Applicant: BEN MULLINS OBO / EUROPEAN AUTO GARAGE**Request:** BUILDING PERMIT**Meeting Date:** 8/9/2021**Address:** 1229 Lovell Rd.**Map/Parcel Number:** 118 H A 3502**Location:** West side of Lovell Road north of its intersection with Blanket Bay Way**Existing Zoning:** CA (General Business) / TO (Technology Overlay) and A (Agricultural) / TO (Technology Overlay)**Proposed Zoning:** N/A**Existing Land Use:** Auto repair facility**Proposed Land Use:** New storage building for facility (secondary use to the vehicle repair facility)**Appx. Size of Tract:** 5.03 acres**Accessibility:** Access is via Lovell Road, a 5-lane minor arterial with a 60-ft pavement width inside a 100-ft right-of-way.**Surrounding Zoning and Land Uses:** North: A (Agricultural) / TO (Technology Overlay) and PC (Planned Commercial / TO (Technology Overlay) - Vet office and single family residences

**8-A-21-TOB
CERTIFICATE OF APPROPRIATENESS**

CONCEPT PLAN
NEW STORAGE BUILDING
EUROPEAN AUTO GARAGE
1229 LOVELL ROAD
KNOXVILLE, TENNESSEE

BUFFER YARD PLAN

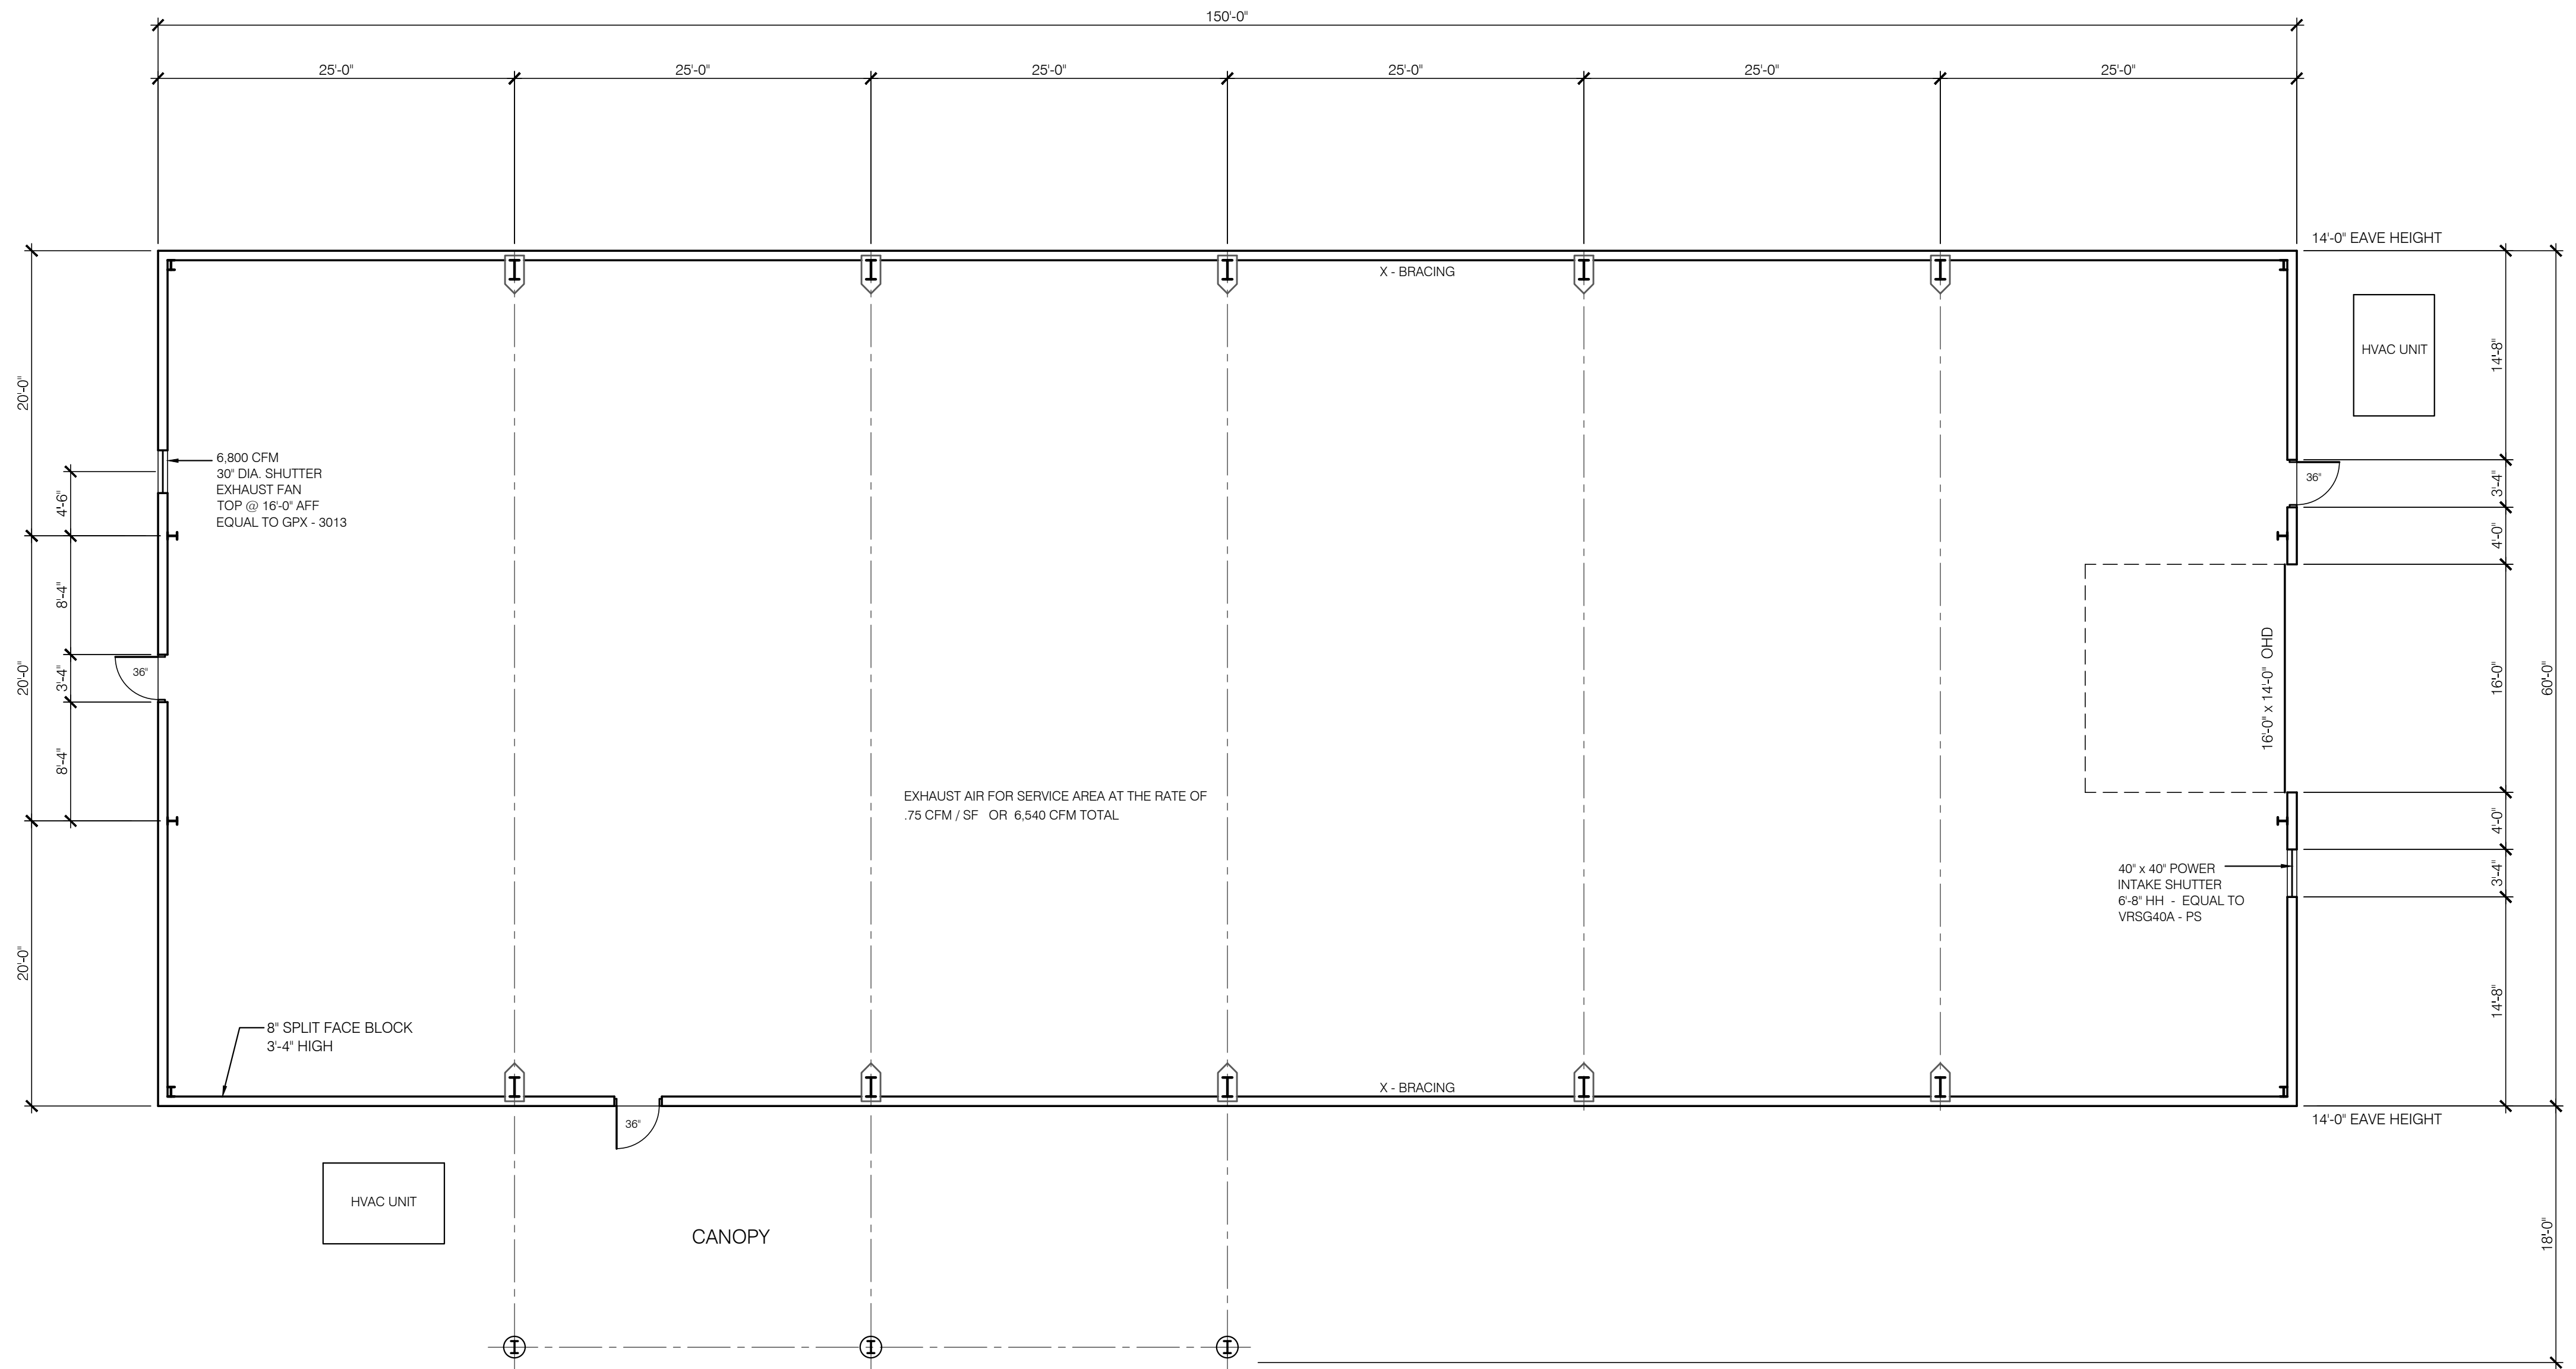
- 8) The landscaping for the existing site was approved in 2016 (see Exhibit A) and is not part of this review. The landscaping plan for the additional building proposes no new landscaping beyond the Type A buffer. The proposed building requires no new parking, and parking lot landscaping has already been installed per the 2016 approval. The only landscaping required for this project is around the perimeter of the building, covering an area equal to 50% of the area of each elevation. A waiver would be required to allow the site to feature no plantings around the perimeter of the building. Since the building is not visible from the right-of-way and is to be screened from residential lots, staff has no issue with the requested waiver from the landscaping design section of the Guidelines.

- 10) Mechanical equipment is proposed in front of the southern and eastern facades. It would not be visible from the adjoining residential lots or the right-of-way. Landscaping is proposed around the HVAC units to screen them from the internal development and the requested waiver is no longer needed.

- 4) APPROVE the waiver to eliminate the requirement of plantings around the perimeter of the building since the building is not visible from the right-of-way and is screened from adjacent residential properties.

Section 3.3.6 requires mechanical equipment, or other unsightly exterior building elements to be screened by landscaping. Even though the rear of the building, where the building's HVAC units were originally intended, would not be visible to the street or adjoining neighbors because of the vegetative buffer and planned landscaping, the revised plans have further mitigated the location of the HVAC until by moving it to the left side elevation (on the opposite side of the neighbors). It is still not visible from the street, but it would further be shielded from the contiguous lots by the building itself. As such a waiver of the requirements of Section 3.3.6 is appropriate.

BUILDING ELEVATIONS

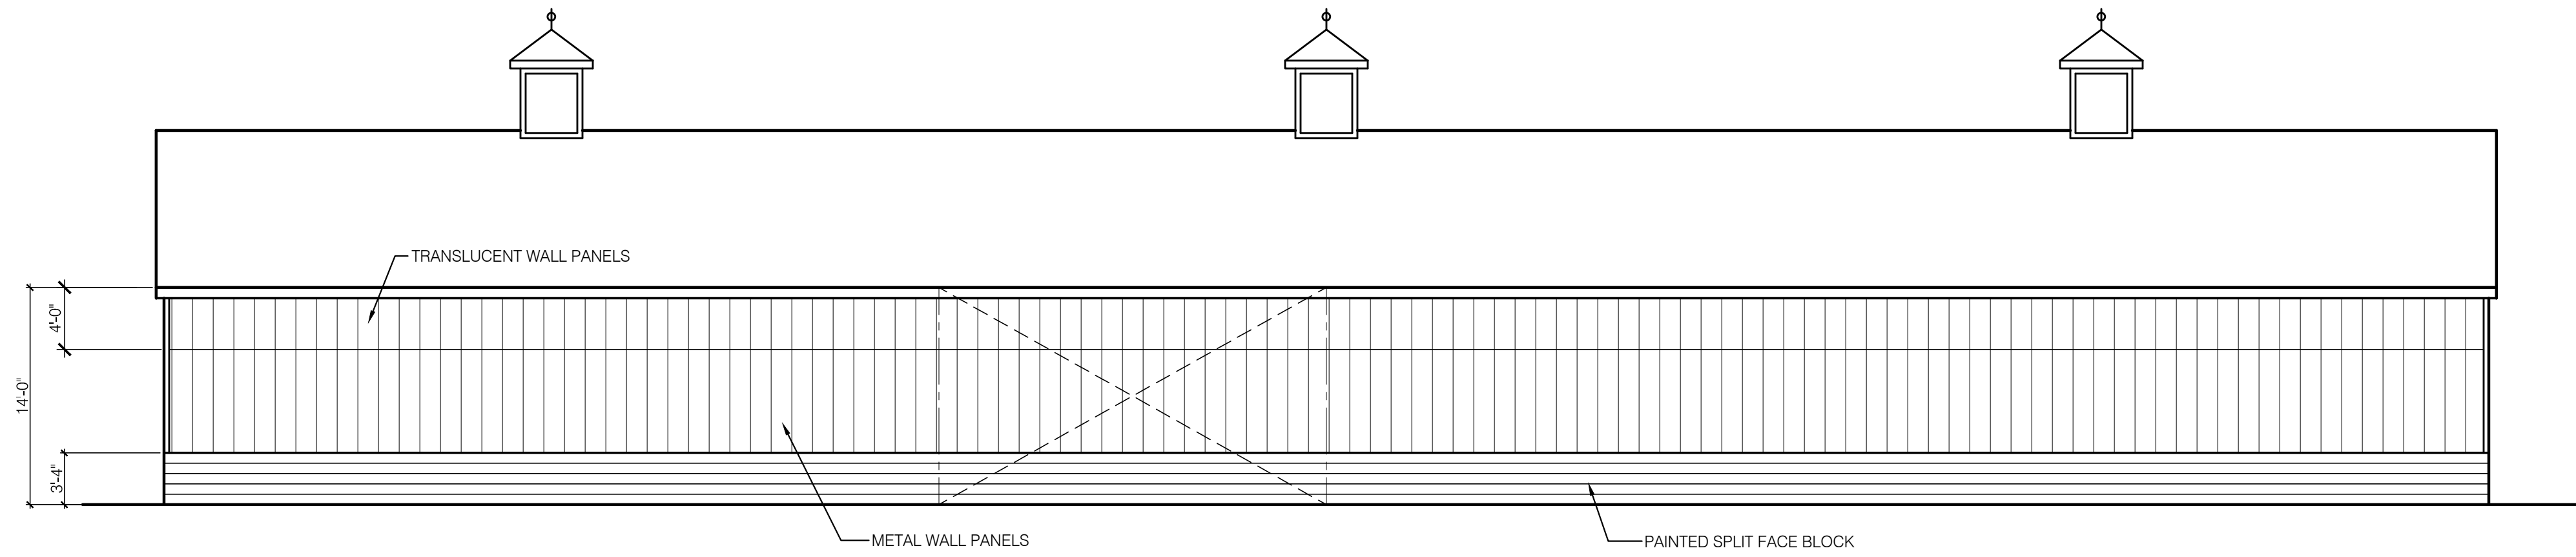
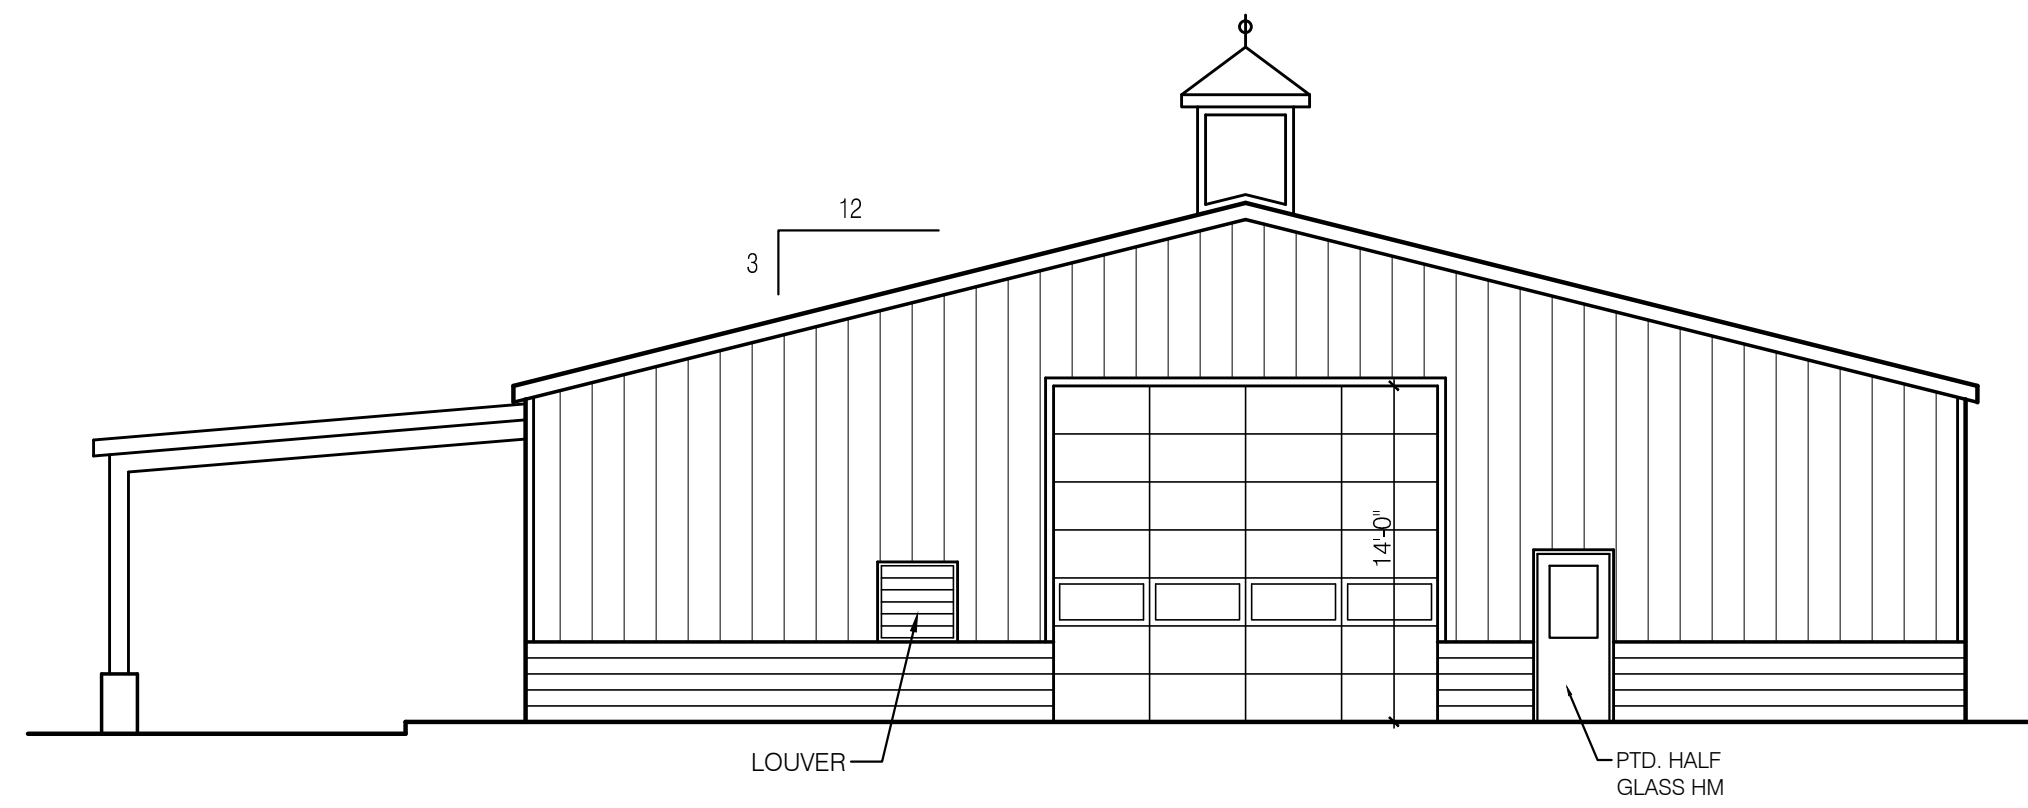
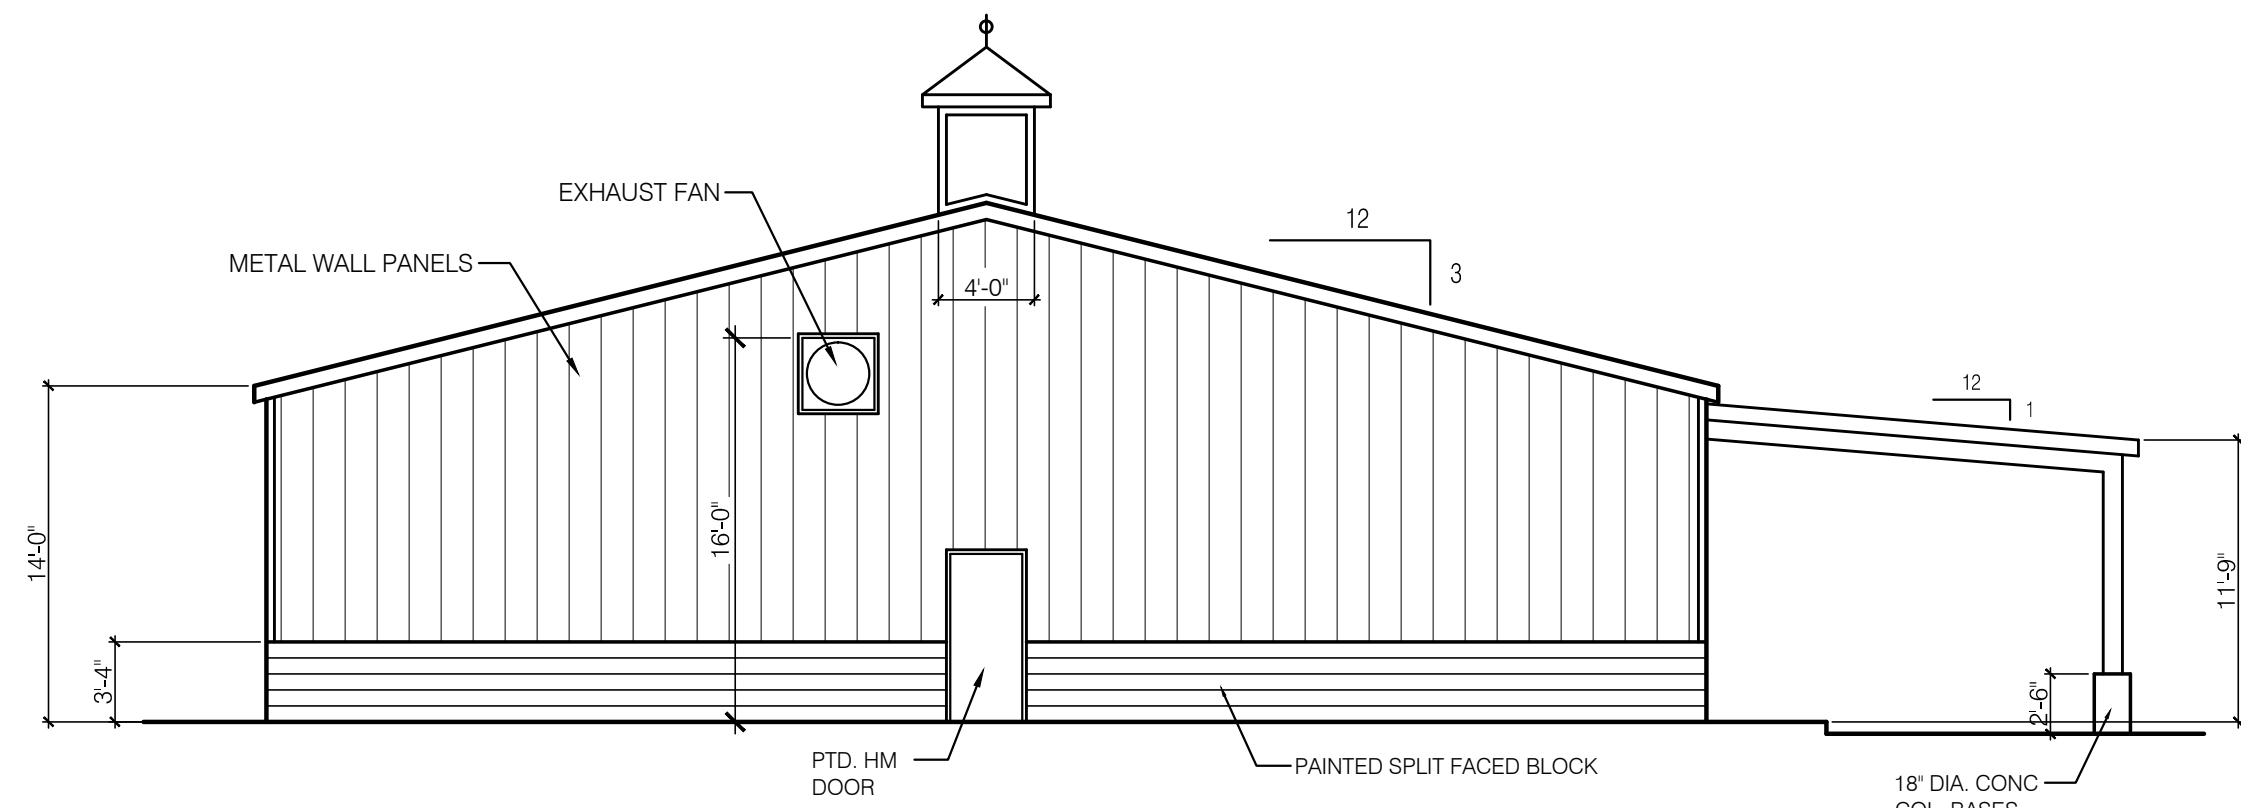
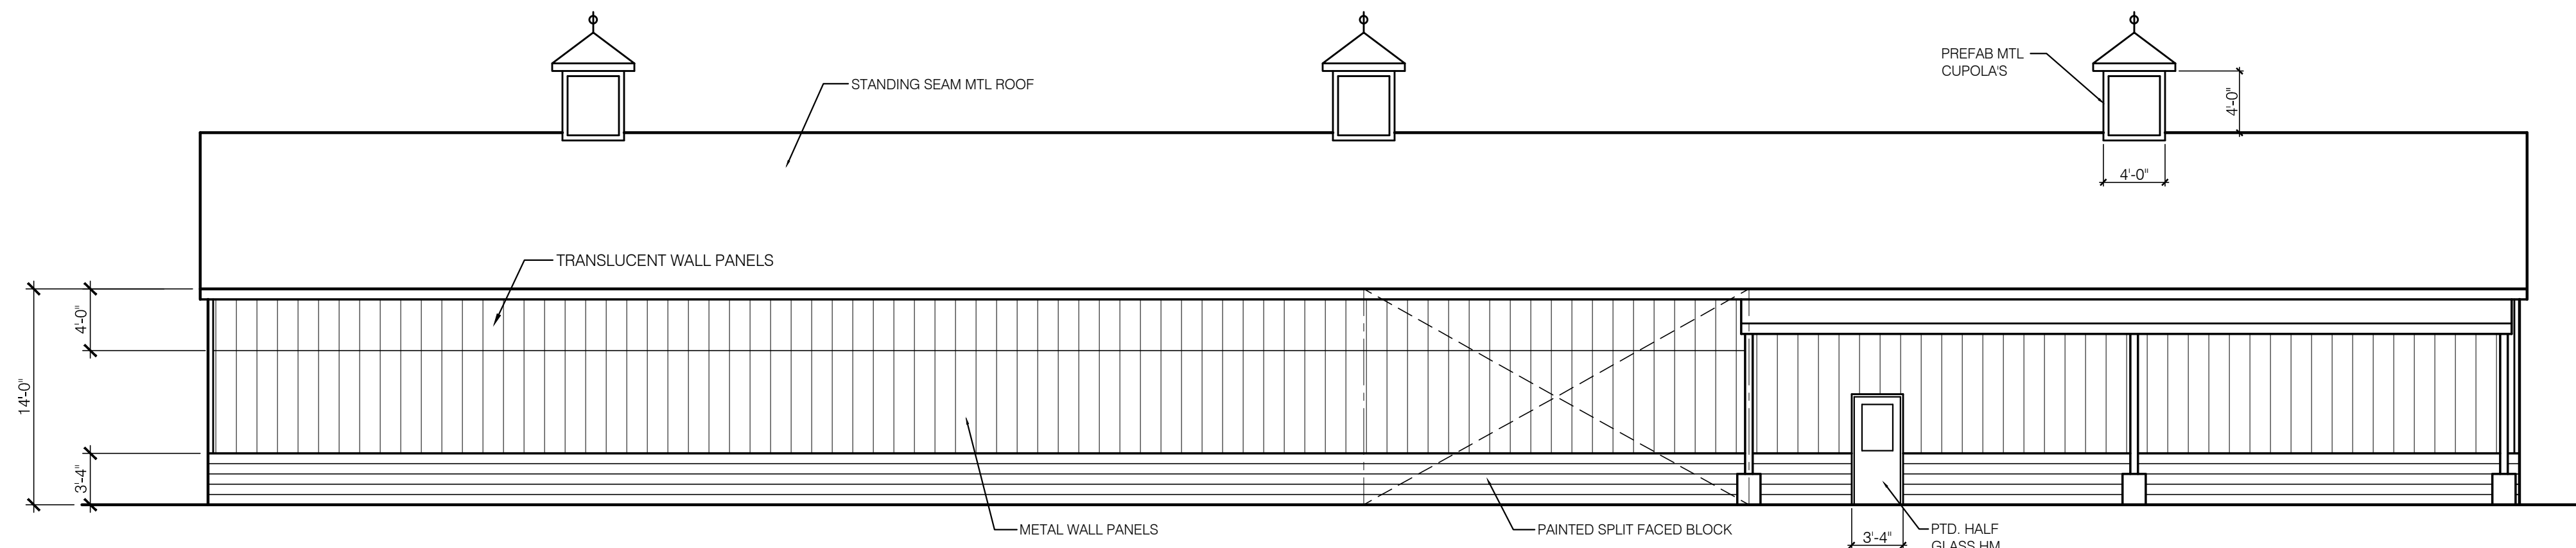
- 9) The proposed building would feature metal panels above painted split face masonry block on the walls and a standing seam metal roof. Both the front and rear facades consist of a long, unbroken wall. Metal panels and long, unbroken façades are discouraged within the TO zones, but not prohibited. The building would not be visible from the street, and would be screened with a landscape buffer from adjoining residential properties. The proposed building color matches that of the existing auto garage.

The Midpoint of the roof line is 17' – 3/4", less than the 35 ft. This can be scaled from the revised plans but is not specifically dimensioned on the revised sheet.

Some of the design aspects of the proposed building, though consistent with the existing buildings, do not technically comply with the TTCDA design guidelines. Specifically, the guidelines state that "Long unbroken facades are discouraged." (Sections 2.1.2 and 2.4.2). This is a suggestive aesthetic guideline and not mandatory (i.e. an absolute prohibition against unbroken facades over a specified length). The concept for the look of the building will be consistent with the entire campus and existing buildings to facilitate a manicured Kentucky equestrian farm aesthetic. To the extent a waiver is required, it is justified insofar as the proposed building design matches the existing structures and forms a more cohesive design.

Similarly, Section 2.2.2 discourages use of nondecorative metal panels. The metal paneling used in this building is intended to mimic a painted barn to further continue the equestrian farm aesthetic. It is consistent with the existing structures and facilitates a more cohesive design. As such, to the extent a waiver of Section 2.2.2 is required, it would be justified.
